Access Compliance Report Public Rights-of-Way (Curb Ramps)

Main Street: FOSTER_RD Cross Street: TUCKER_LN Location: NE

ADA ID: RPRK211209122645 Ramp Type: Type 1 - Perpendicular Diagonal Initial Pass/Fail: Pass Overall Compliance: No Severity Score: 10

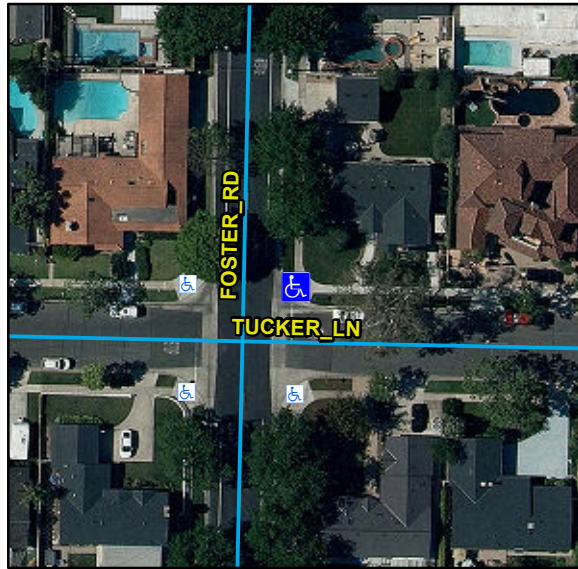
R204.3, R305, STD 1115

Remove & Replace Curb Ramp With Two New Directional Ramps or Equivalent.
